PUBLIC HEARING: Review Resolution #20-028 Revised Preliminary Plat for Riverstone (Project 17-106, 19-149); Case of Capstone Homes, Inc.

PRELIMINARY SITE & UTILITY PLAN

DATE	12/30/19	PROJECT ADDRESS	RIVERSTONE DEVELOPMENT
PROJECT TITLE	RIVERSTONE ADDITION (PRELIMINARY PLAT REVISION)		
PROJECT #	17-106		
DEPARTMENT:	Community Development – Planning Division		
TECHNICAL REVIEWER:	Name: Tim Gladhill, Community Development Director Phone: 763-433-9826 Email: tgladhill@cityoframsey.com

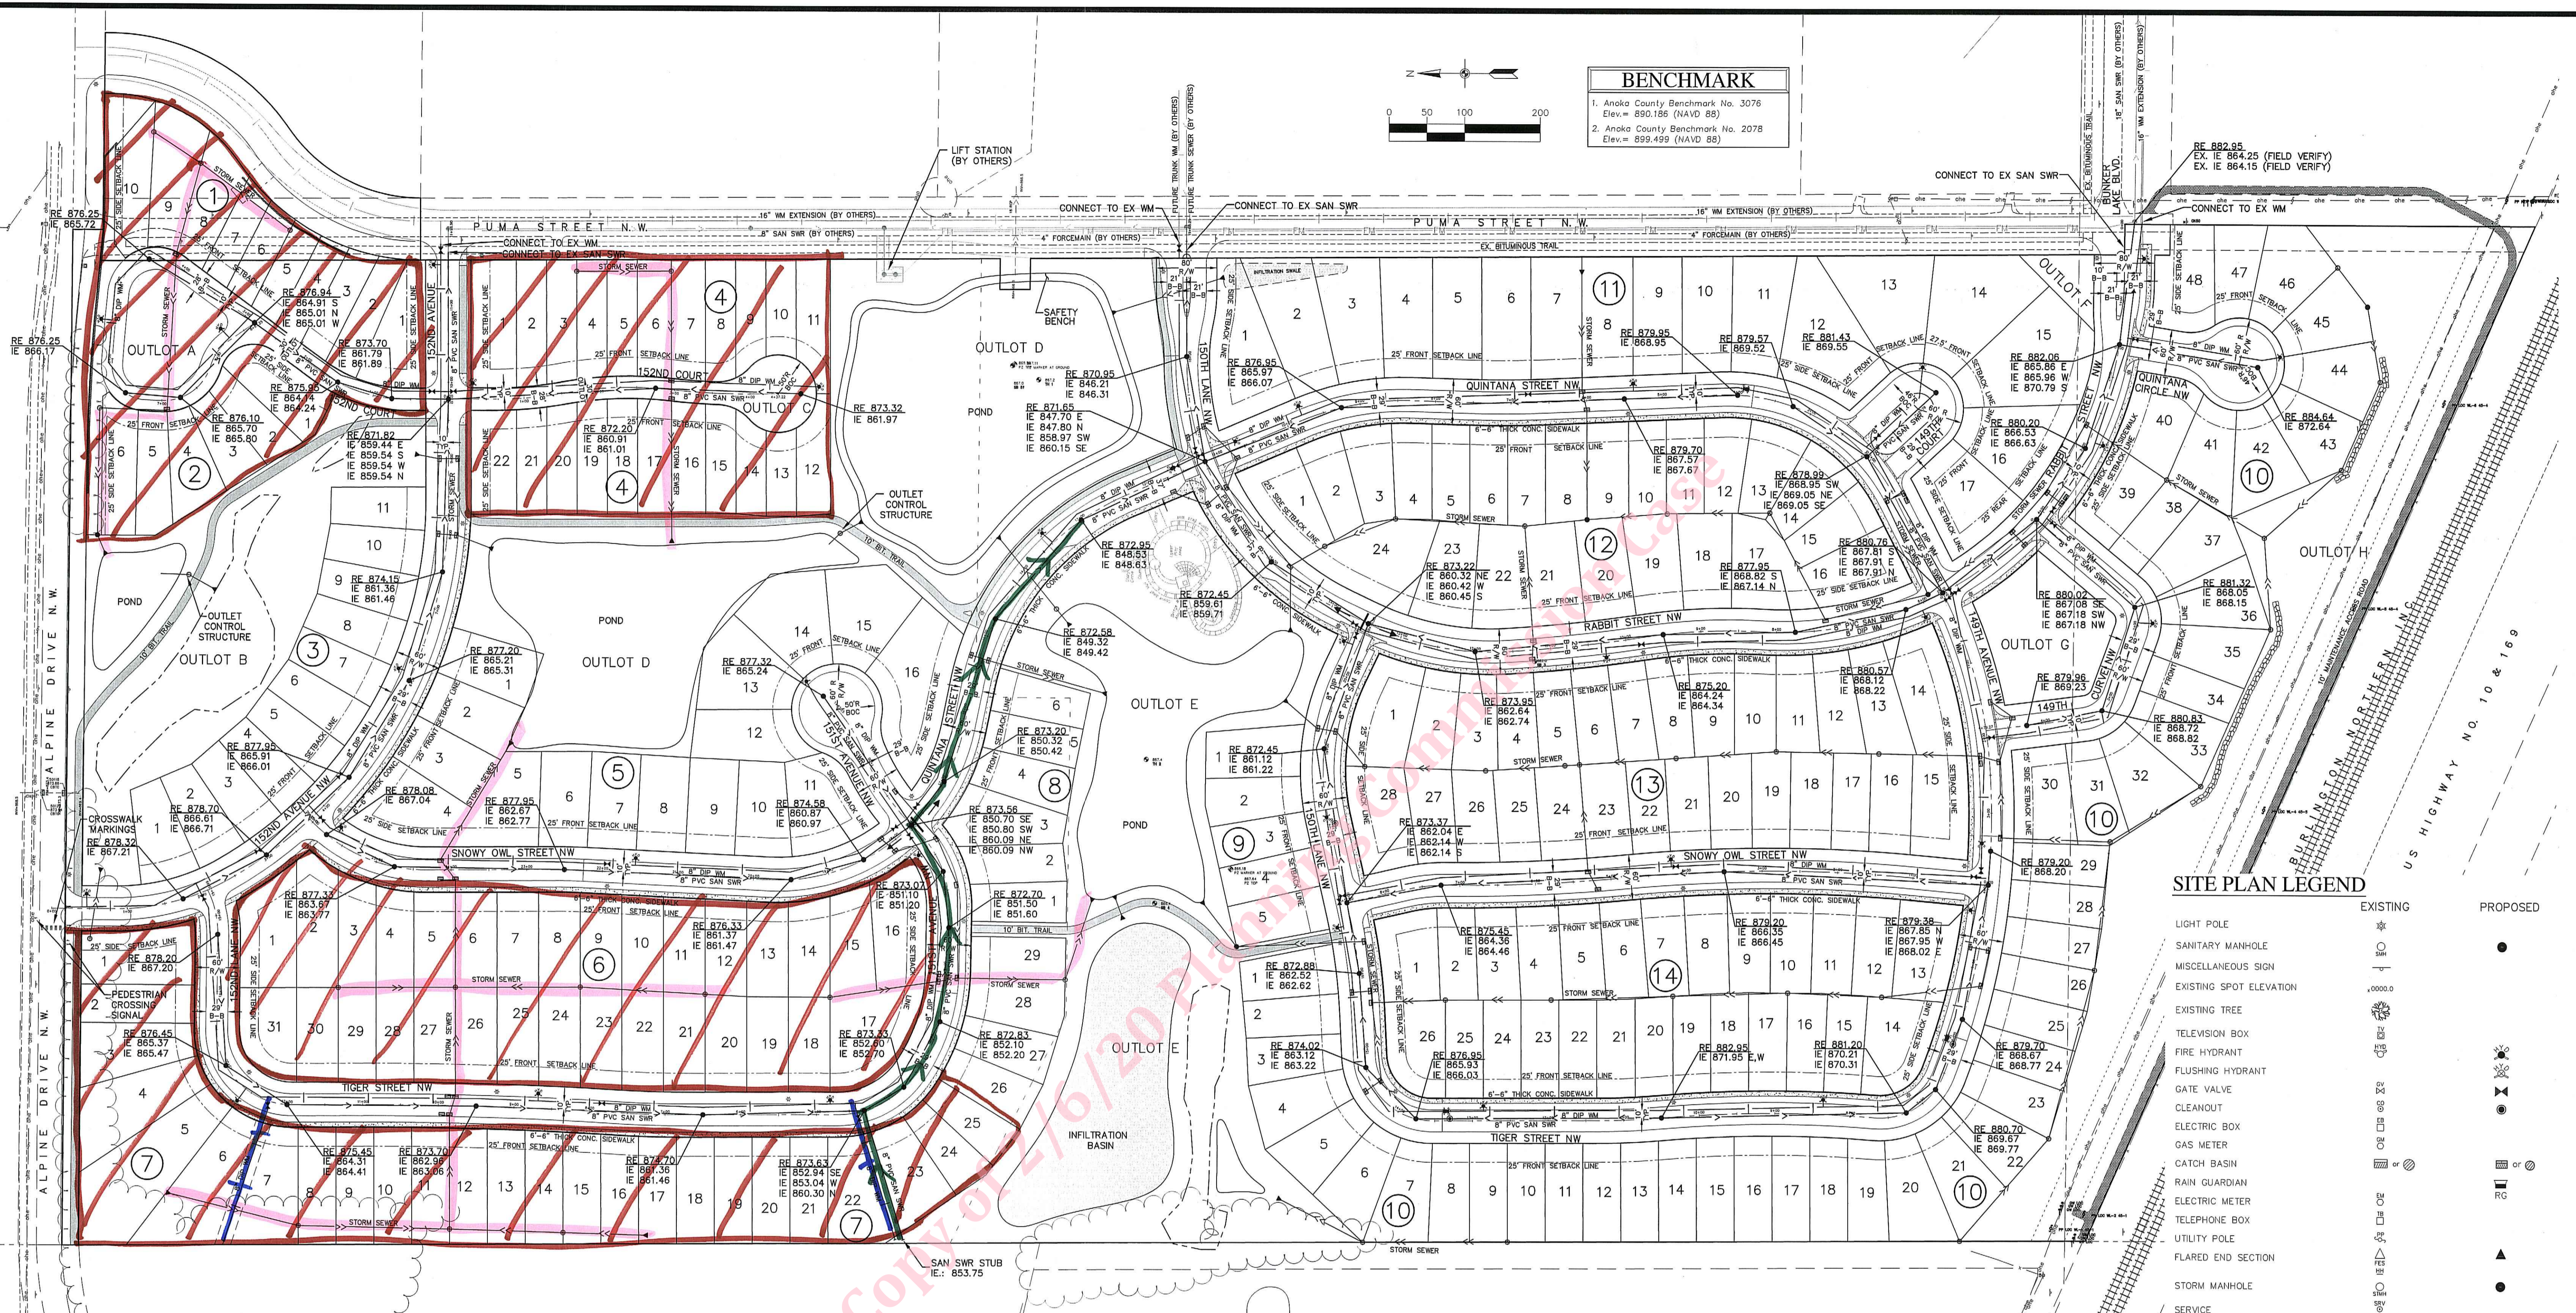
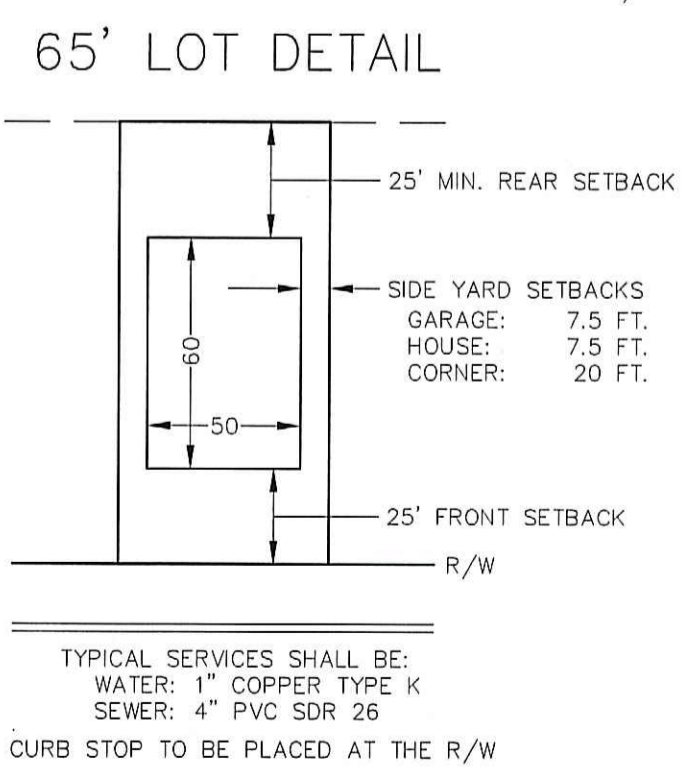
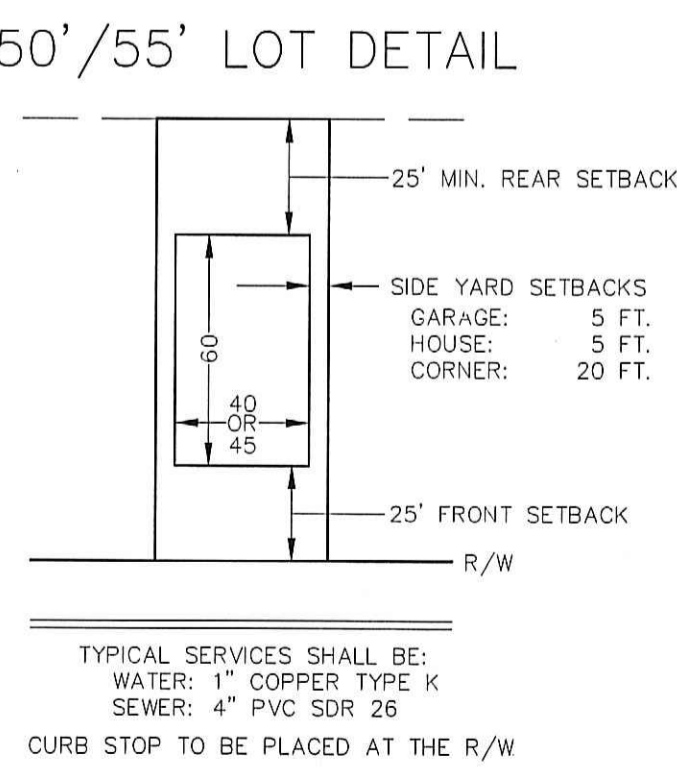
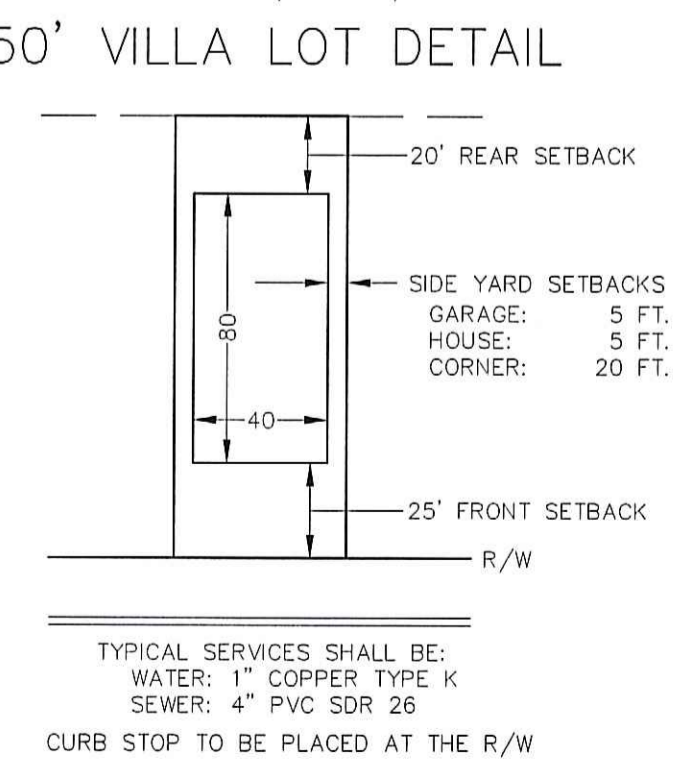
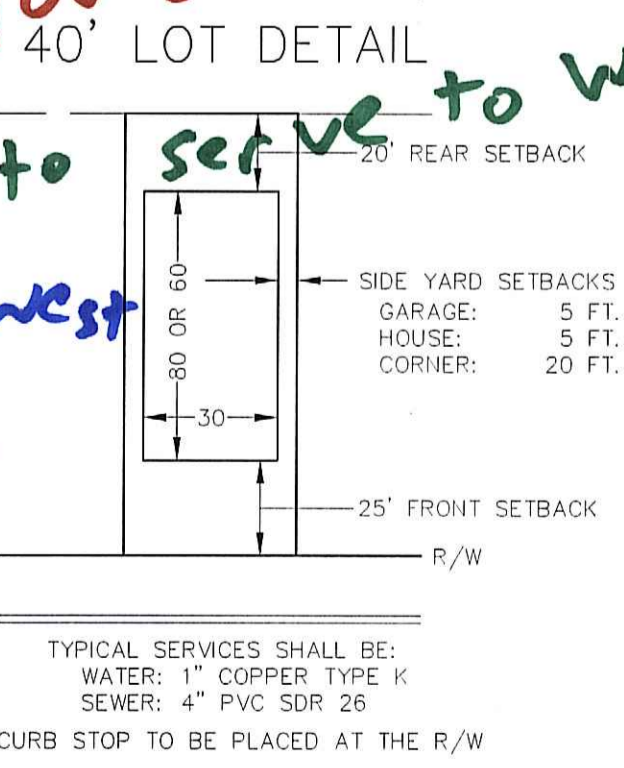
Utility Changes:

- Sanitary sewer and water depth changed to serve parcel directly to west between Block 6 and 8
- Sanitary sewer changes across Blocks 1, 2, 4, 6 & 7
- Watermain stubbed west to serve parcel directly to west through block 7

Please note that the utility changes were requested to serve the parcel to the west (currently under application for Sketch Plan from BK Land Development)

Riverstone Comprehensive Plan Change Exhibit
11/14/19

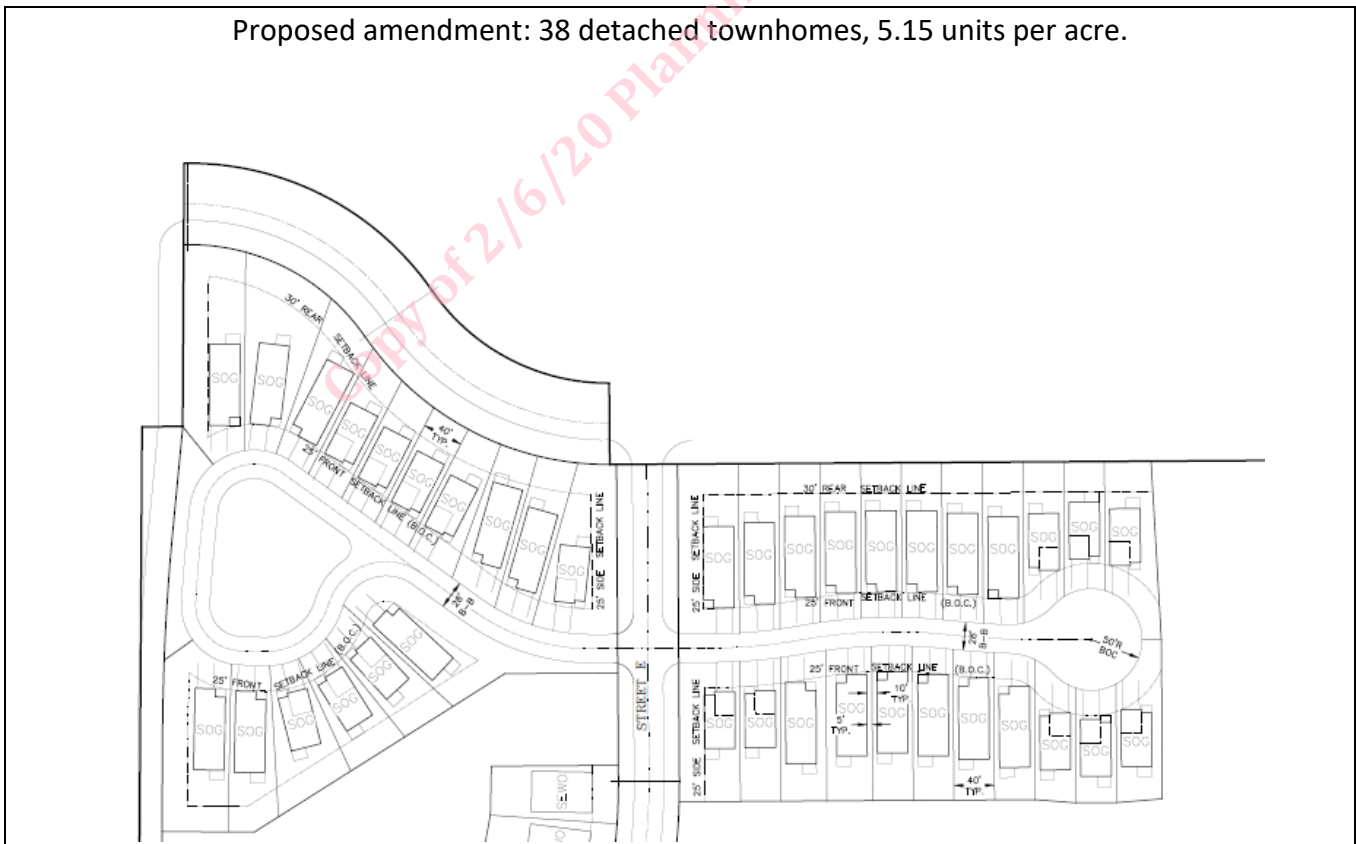
Per our conversation earlier this week to modify Riverstone's preliminary plat to include detached townhomes instead of quad townhomes, we are requesting a Comprehensive Plan Amendment for Riverstone.

Attached is a site plan exhibit of the area. As approved, there are 48 attached townhomes. The revised plan would have 38 detached townhomes. The density would change from 6.5 units per acre to 5.15 units per acre.
